**TECHNICAL MEMORANDUM NO. 2  
TO FINAL PHASE I RFI/RI WORK PLAN  
MODIFICATIONS TO FIELD ACTIVITIES**

**ROCKY FLATS PLANT  
SOLAR EVAPORATION PONDS  
(OPERABLE UNIT NO. 4)**

**EG&G ROCKY FLATS, INC.  
ENVIRONMENTAL RESTORATION MANAGEMENT**

**MAY 1993**

FIGURE 3-1  
REVISED LOCATIONS  
OF BOREHOLES - T.M. 2  
SOLAR PONDS - 0014

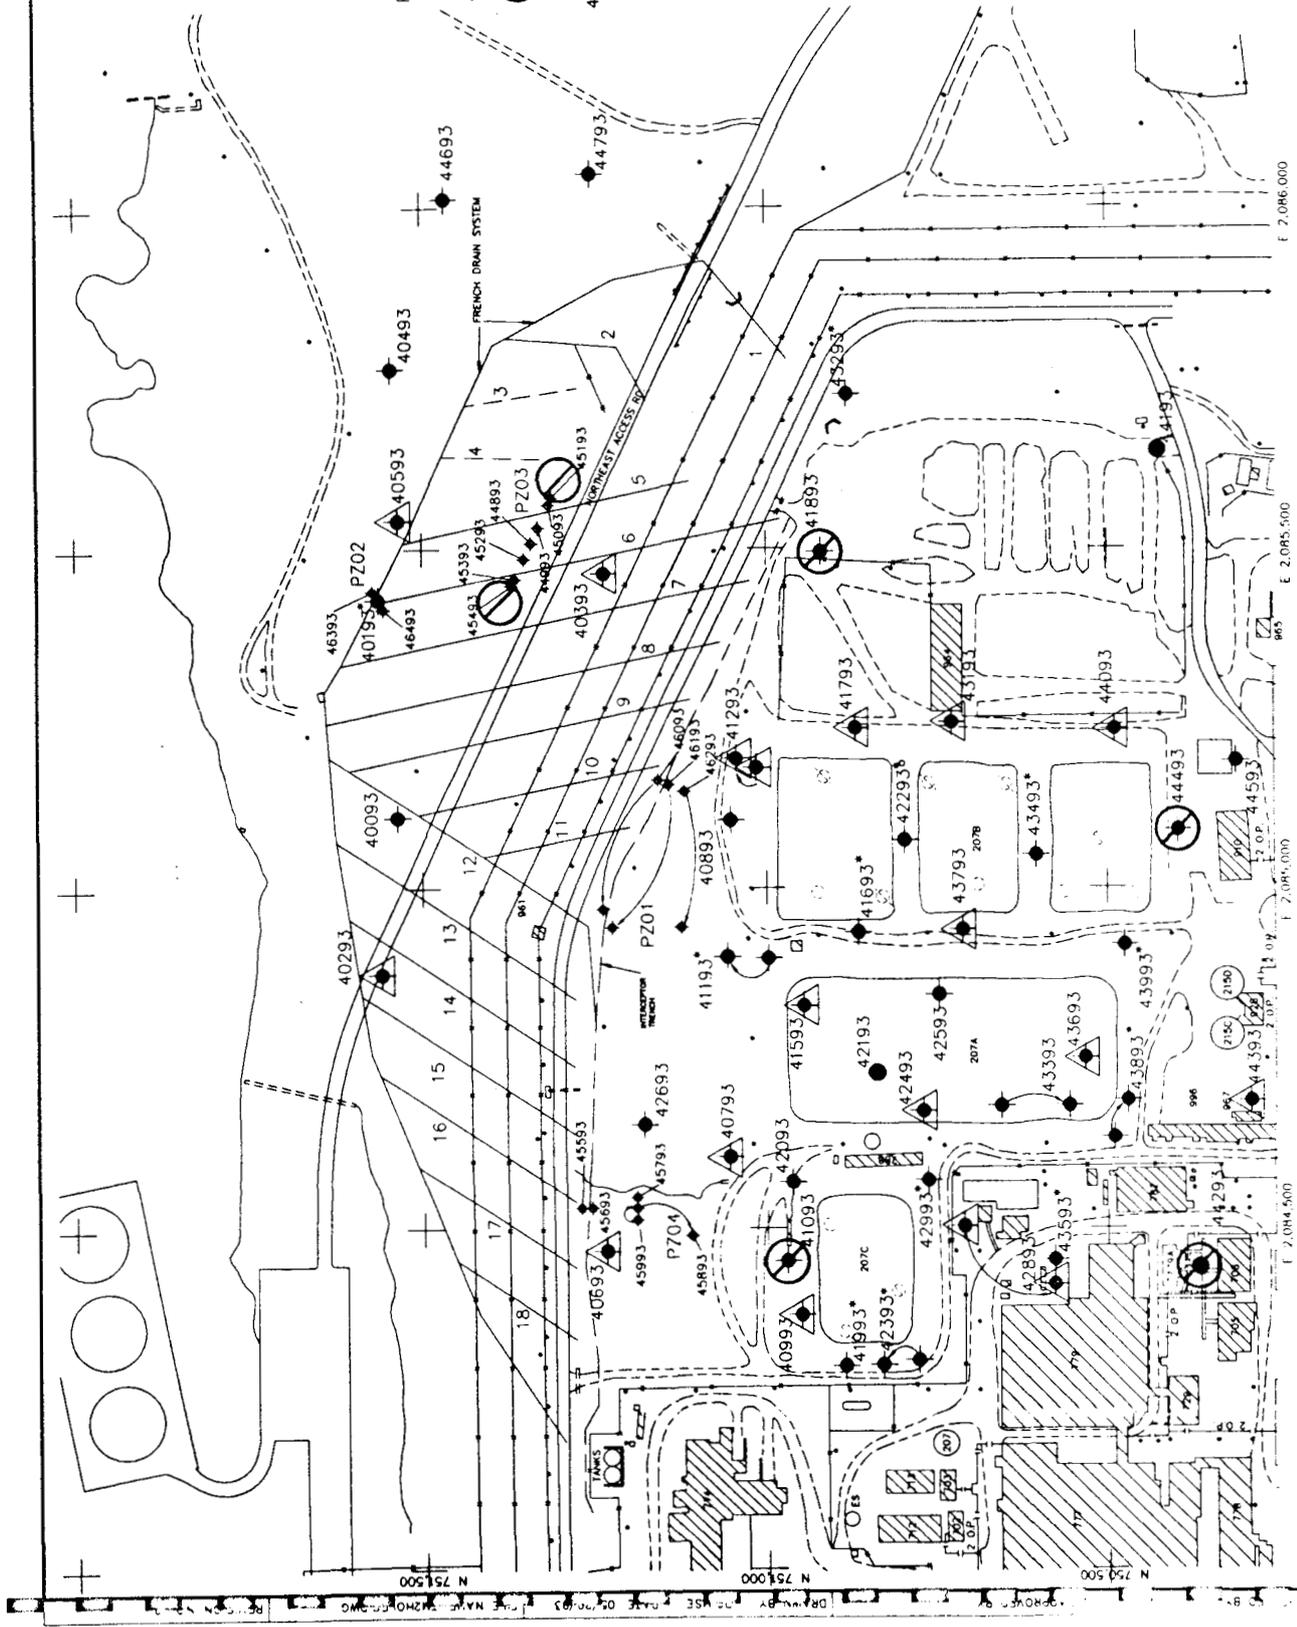
Eight borehole numbers initially assigned to borings inside the ponds (Figure A-2) have been used to identify interim boreholes as shown on Figure 3-1. Borehole numbers 41393 and 41493, originally proposed in Pond 207C, as well as Boreholes 42793 and 43093, originally proposed in the 207B-series Ponds, were not given to interim boreholes, and have been postponed until the 207B-series Ponds and Pond 207C are cleaned of liquids and sludges. Drilling of twelve boreholes may be required to adequately characterize materials under the Solar Ponds after all waste is removed from the 207B-series Ponds and Pond 207C.

As discussed earlier in this TM, presence and direction of alluvial ground water flow in OU4 are now understood to be highly localized and governed by bedrock surface. After drilling activities commenced in OU4, it was recognized that valuable alluvial ground water data could be generated from the completion of several analytical boreholes originally scheduled for abandonment as alluvial piezometers. This change did not impact the original intent of the boreholes because lithologic and geochemical data would be generated from these boreholes as planned. The installation of piezometers in these boreholes will provide long-term data in the alluvium for minimal additional effort and cost. Analytical boreholes remaining to be drilled after the concept was recognized were constructed with alluvial piezometers including Boreholes 40193, 41193, 41693, 41993, 42293, 42393, 42993, 43293, 43493, 43593, 43893, and 43993. They are indicated with an asterisk on Figure 3-1.

The value of data to be obtained from each borehole in the program is continually being evaluated to maximize the overall program efficiency and benefit of data collected. After the development of interim borehole locations, several boreholes were identified which seem to provide redundant data or data not considered pertinent to the OU4 program. The following paragraphs identify the four boreholes along with the rationale for their suggested deletion from the program. Their locations are shown on Figure 3-1.

FIGURE 3-2  
 RANDOM & DISCRETE SURFICIAL  
 SOIL SAMPLE LOCATIONS  
 SOLAR PONDS -- OU 4

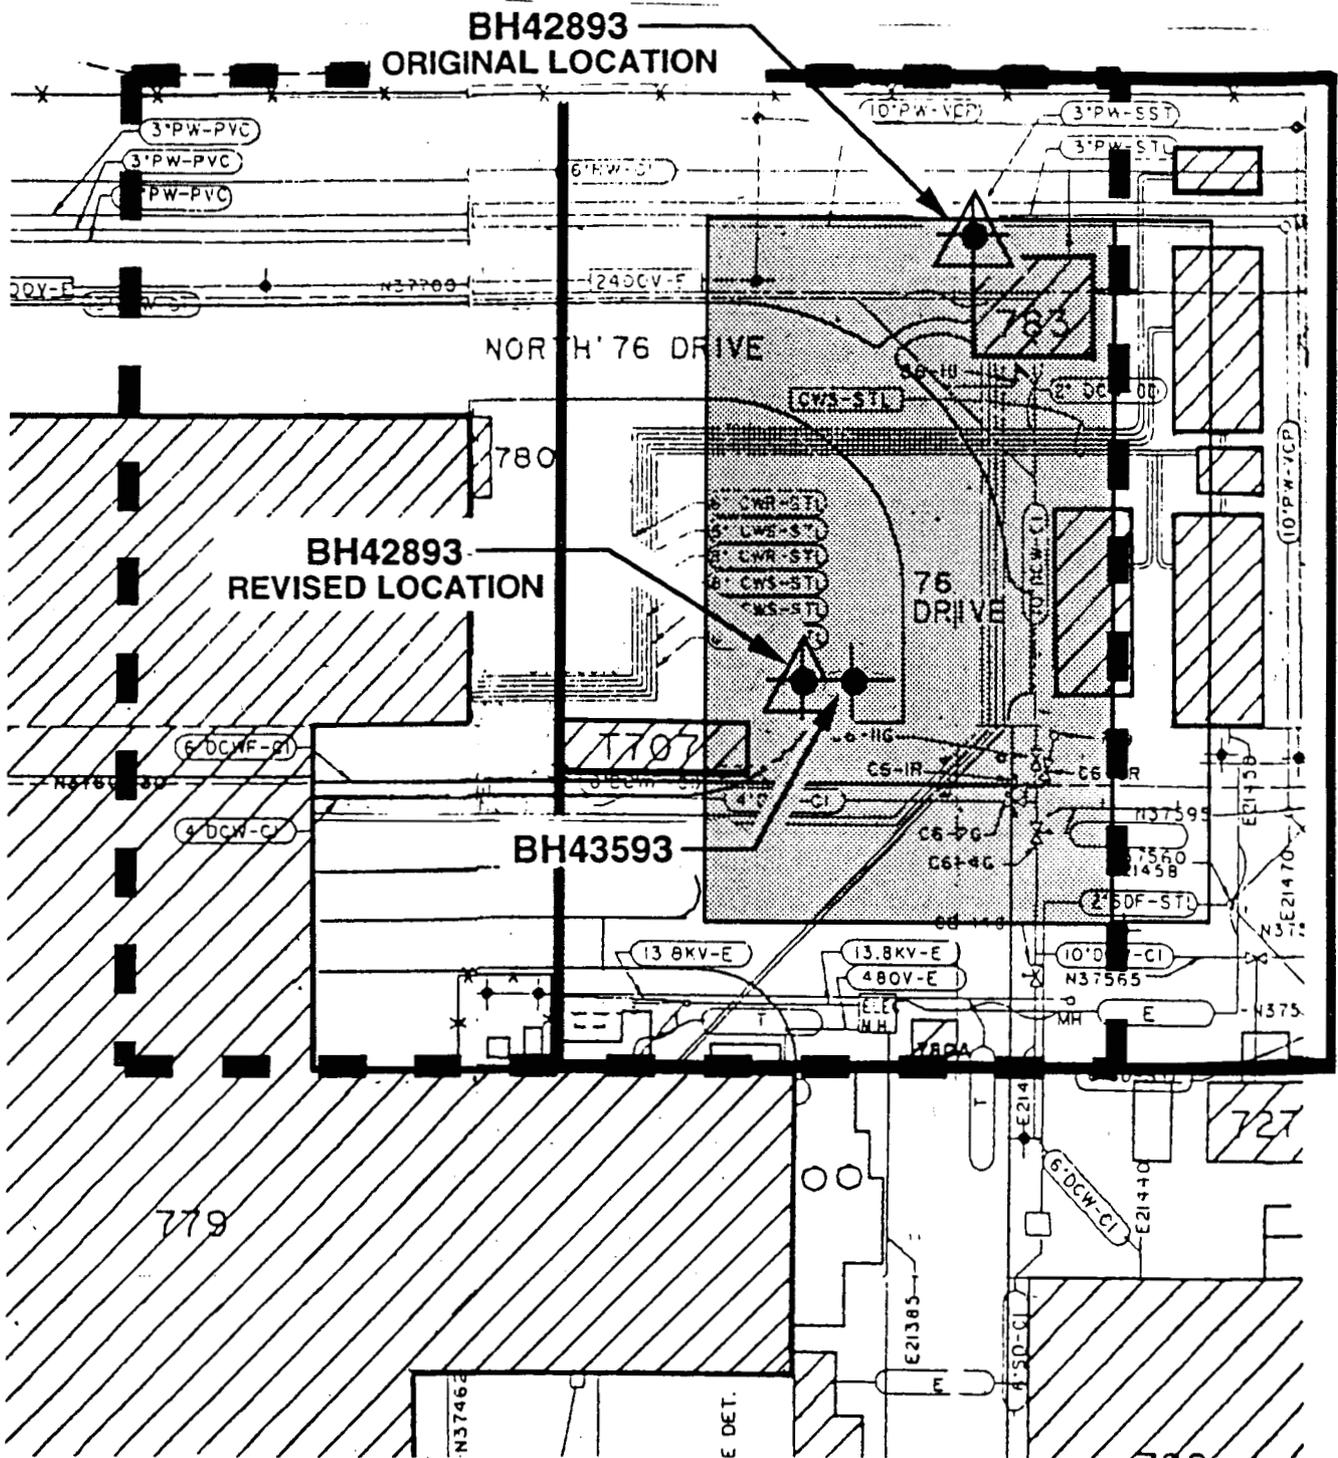
After reviewing FIDLER radiological survey results, it was proposed to collect three surficial samples at the grid locations shown in Figure 3-2:

- Surficial soil sample number 32 is proposed to be collected in the triangle shaped seep located north of and between ponds 207C and 207A. The seep is in the location where the Building 779 footing drain daylight; and
- Surficial soil sample number 33 is proposed to be collected in the small oval shaped seep located north of Pond 207A. During the March site walk, the seep was observed to be significantly larger than in Fall, 1992. The seep was observed to extend approximately 100 feet west of the location shown on the attached figure. Piezometer nest 04 was installed in the vicinity of this seep. It is proposed a surficial soil sample be collected in the seep.

PROPOSED SAMPLING PLAN WITHIN  
POND 207A—BOREHOLE 42193

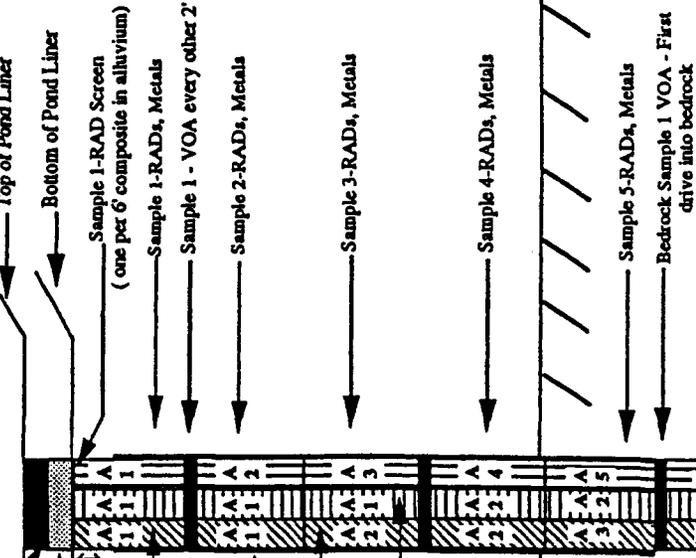
The proposed sampling procedure for Borehole 42193 is presented in Figure 3-4. Sampling of the pond liner and alluvial components of Borehole 42193 are as described in the previous paragraph. Deeper bedrock sampling from this borehole is proposed to be conducted using the standard 6-ft composite intervals throughout the bedrock until either a maximum depth of 50 feet or evidence of sandstone or ground water is encountered. It is preferred that an offset casing be installed in the deep hole to allow geologic logging to proceed with neutron, gamma, and

PROPOSED SAMPLING PLAN WITHIN  
POND 207A—BOREHOLES  
43393 AND 42593

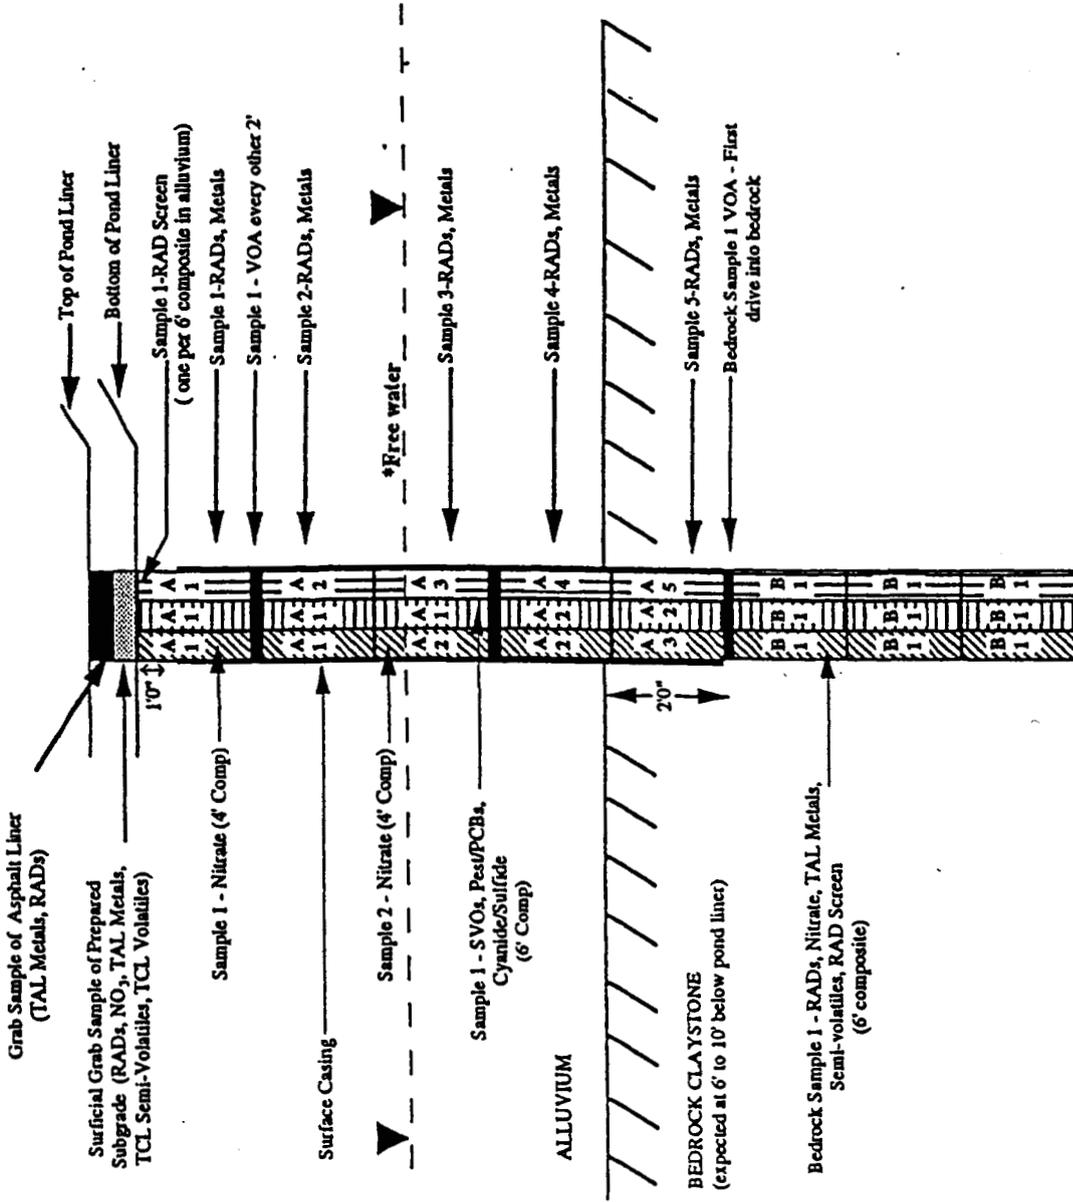
Boreholes 42593 and 43393 are the two remaining analytical boreholes in Pond 207A. Sampling procedures for these boreholes are consistent with that described above for the alluvial materials, but at least one sample is also proposed in the underlying bedrock. Figure 3-5 depicts the proposed sampling scheme. After alluvial material are sampled, a surface casing will be installed, and the borehole advanced 6 to 8 feet into bedrock. A 6-ft composite sample will be collected and analyzed from bedrock to allow comparison of geochemical data between alluvial and bedrock materials. The boreholes will be abandoned upon completion.

FIGURE B-1  
**LOCATIONS OF SOIL BORINGS**  
 PRESENTED IN T.M. NO. 1  
 SOLAR PONDS - OU4

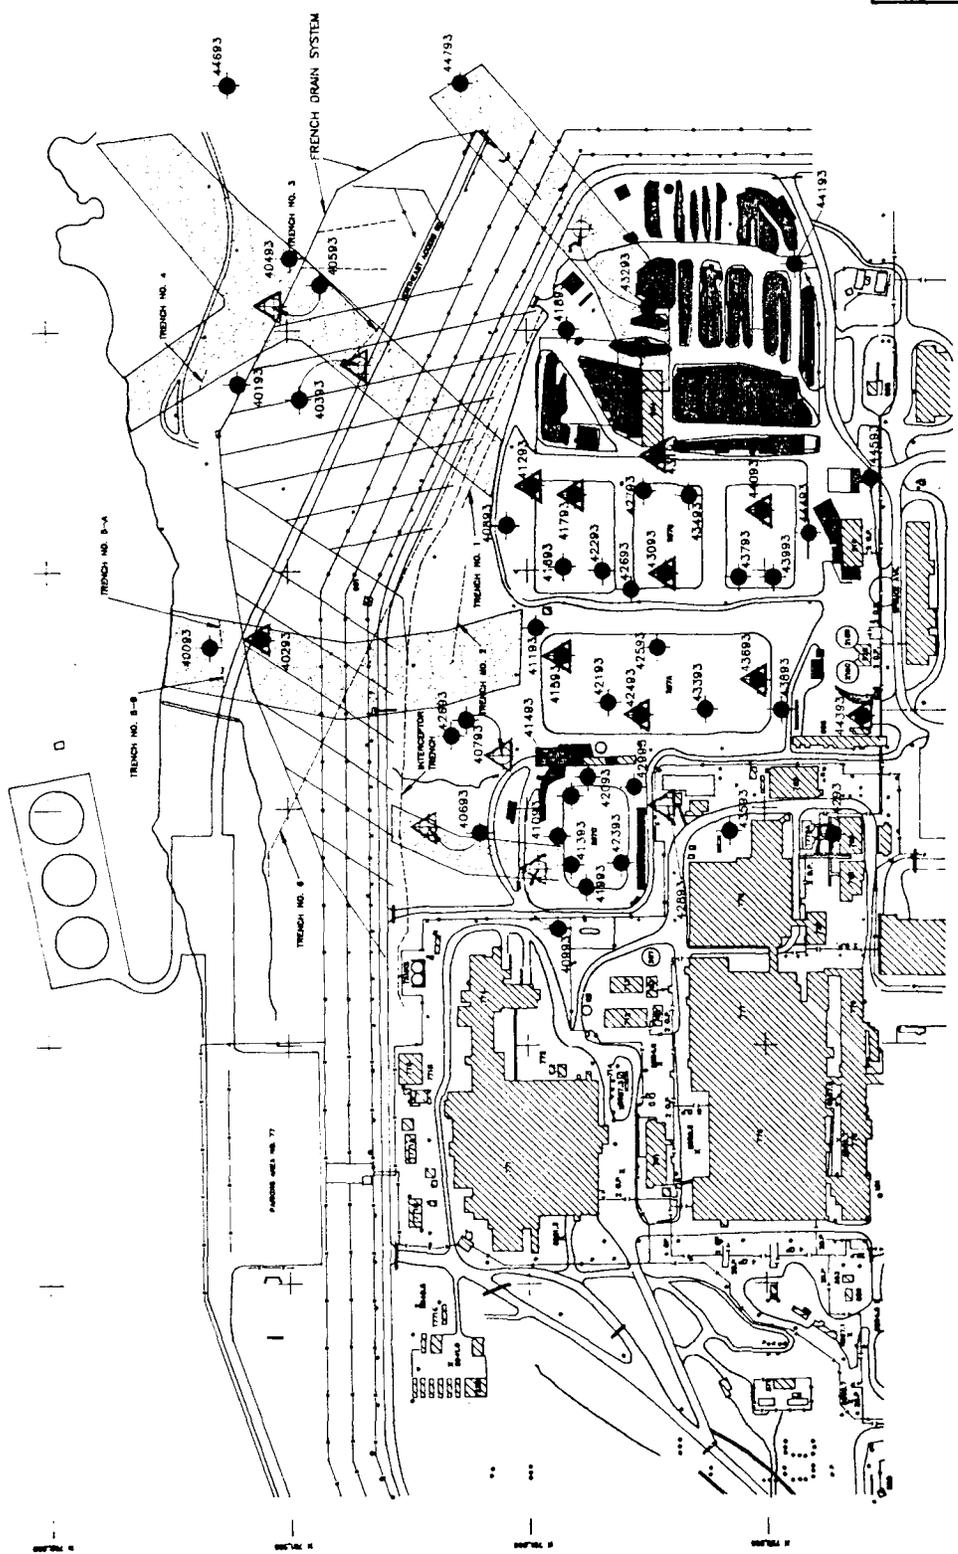
Interim Borehole 41793 is located near the southeast corner of Pond 207B-North. The borehole number was originally located within Pond 207B-North (Figure B-1). Data evaluation efforts indicate that a bedrock low exists near the southeast corner of Pond 207B-North, representing potentially the lowest point in the bedrock surface beneath all of the ponds. It is likely that potentially contaminated ground water could migrate in that direction beneath the Ponds. Based on water level measurements from nearby Well 2886, there is an approximate 3-foot average annual fluctuation in ground water in the general location, with the typical high water level approximately 4 feet below the ground surface. Vadose zone monitoring equipment to be installed in Borehole 41793 will monitor the potential contamination in the vadose zone which can be correlated and compared to data generated from an alluvial well in the area. Additionally, the placement of vadose zone monitoring instrumentation in this location is based on the fact that although the typical annual water level high is approximately 4 feet below the surface, a one-time recorded event in the alluvial well in the area indicated the ground water level was within approximately 1 foot of ground surface. Vadose zone monitoring equipment will therefore monitor potential residual contamination introduced into the soil by contaminated ground water and the leaching or removal of this contamination over time.
